## Planning Commission Staff Report

August 27, 2014  
Item 6.b.

- SUBJECT:** PUD-106
- APPLICANT:** John Gutknecht, Habitec Architecture
- PROPERTY OWNER:** Alameda County Surplus Property Authority
- PURPOSE:** Application for PUD Development Plan for the construction of an automobile dealership consisting of an approximately 31,792-square-foot building with a 2,175-square-foot service canopy and 1,250-square-foot car wash, and related site improvements on the Auto Mall site at Staples Ranch.

**Figure 5: Proposed Landscaping Plan**

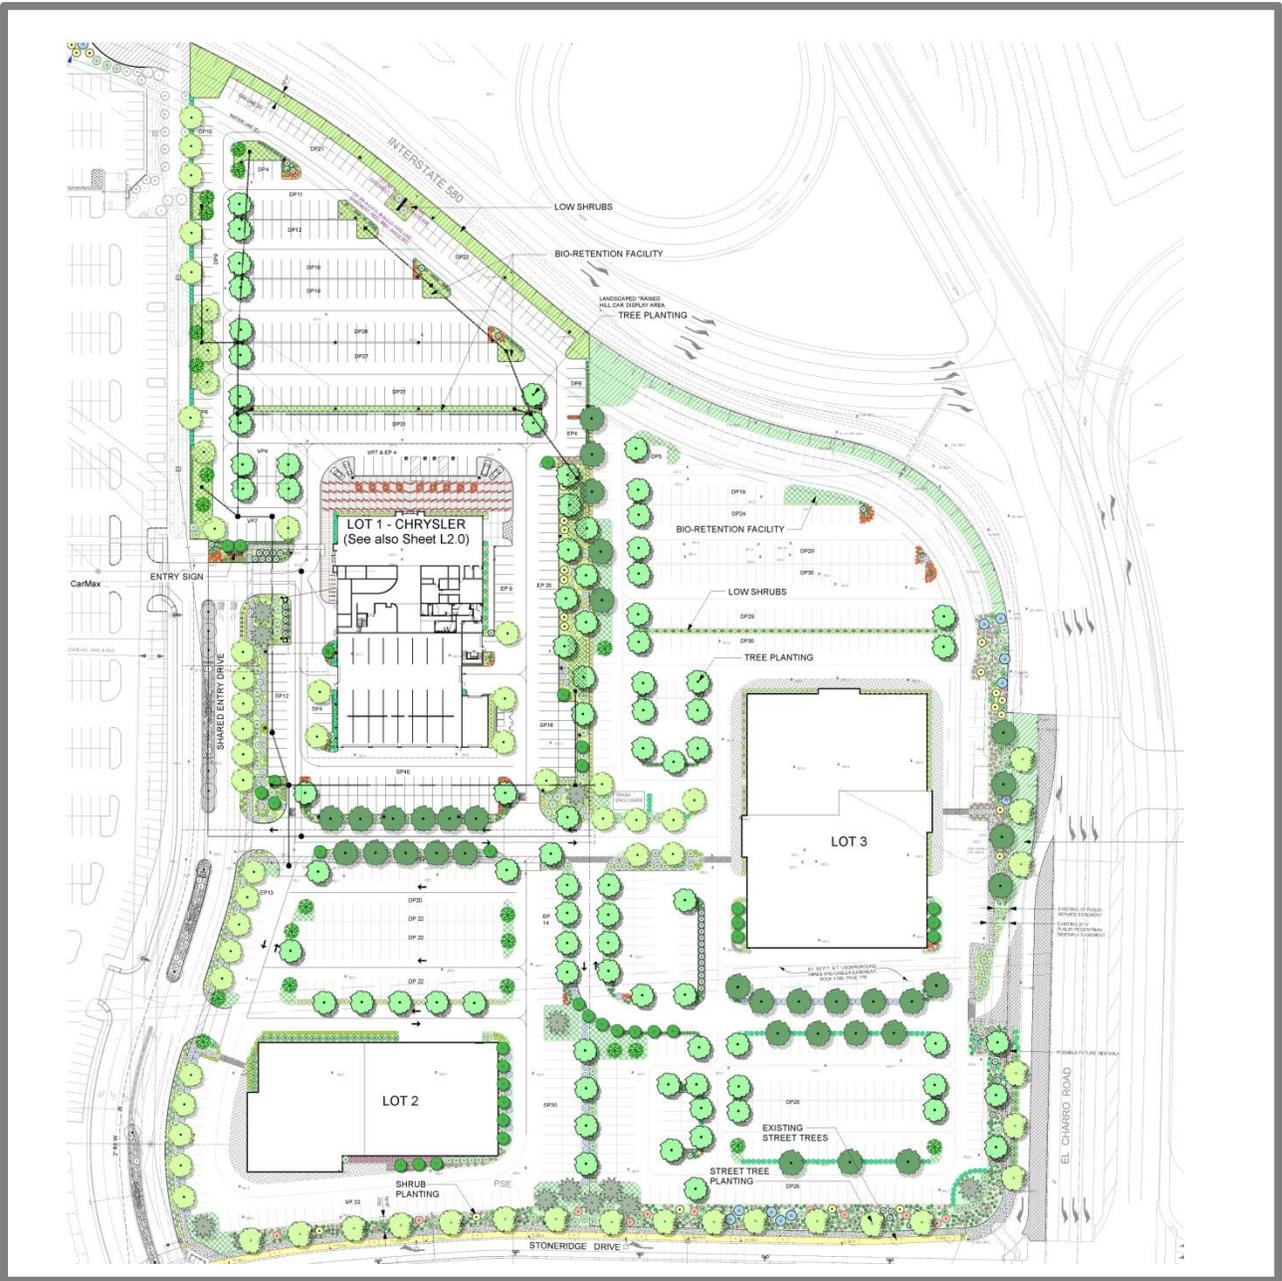
Proposed tree species (all are proposed to be 24-inch box size) include: Sawleaf zelkova, Deodar cedar, Pink crape myrtle, Flowering pear, Coast live oak, and Mexican palo verde. The trees are located around the perimeter of the 16-acre site and around the anticipated boundary of the 5-acre site. A condition of approval requires the applicant to identify the proposed tree species along Stoneridge Drive and El Charro Road, and along the shared entry drive approved for the CarMax Auto Superstores application, and to ensure the species and planting spacing is consistent with nearby existing conditions for overall consistency.

A variety of shrubs and ground cover are proposed in various planter and bio-retention areas. Landscaping has been incorporated in planter boxes (approximately 3 feet high) directly in front of the dealership’s northern façade, and around the northern, eastern, and western building perimeters (the southern façade consists of roll-up doors for vehicular access to the service area). Planting would be tolerant of recycled water. Figure 5 shows the proposed landscaping plan.

**Figure 6: Additional Landscaped Area**

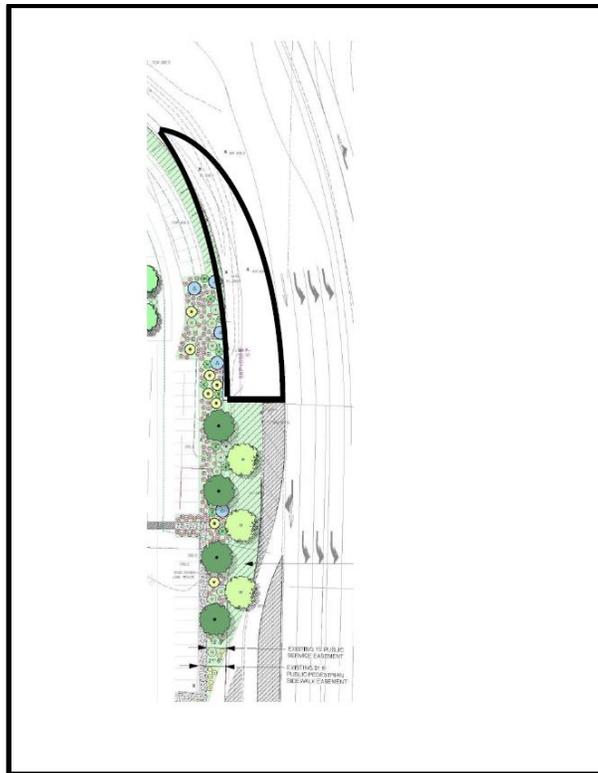
While only 5 of the 16 acre site would be developed at this time, a condition requires that landscaping around the perimeter of the entire 16 acre site be provided. Further, conditions require that if permitted by CalTrans, the applicant provide landscaping at the northeast corner of the 16 acre site, the project site's I-580 right-of-way, and the "triangle-shaped" area south of the off-ramp as indicated in Figure 6.
